N9937A-05A

Modification Recommended Service Note

N9937A - 18 GHz FieldFox RF analyzer

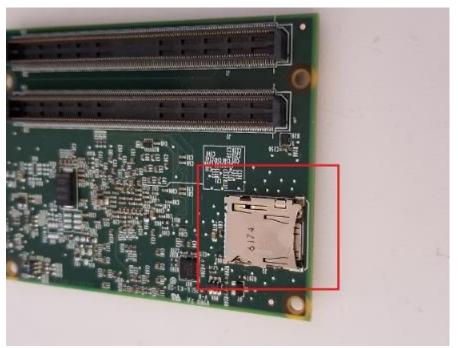
c. Using an Exacto Knife remove the Epoxy bridge holding the SD Card into the SD card socket.

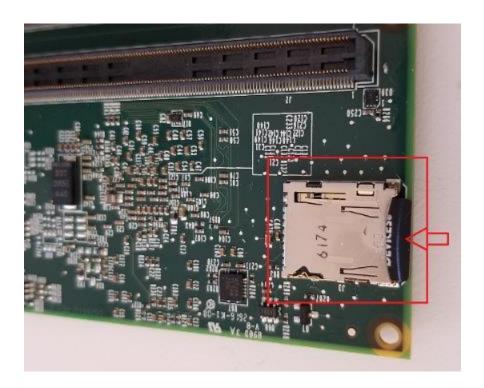
f. Here are the Old and New SD cards. The old SD card (Patriot) is on the left. The New (Delkin) is on the right.

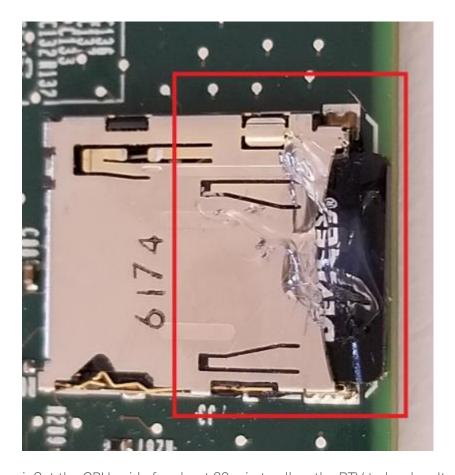
g. Insert the NEW SD card into the SD card socket and press it in until you hear a click, then release. The SD card is now locked in the socket.

h. It is now necessary to add a small amount of RTV (part number 0470-0450) to bridge the SD card to the SD card socket. Using a wooden Q-Tip place a small amount of RTV on both the SD card and the socket.
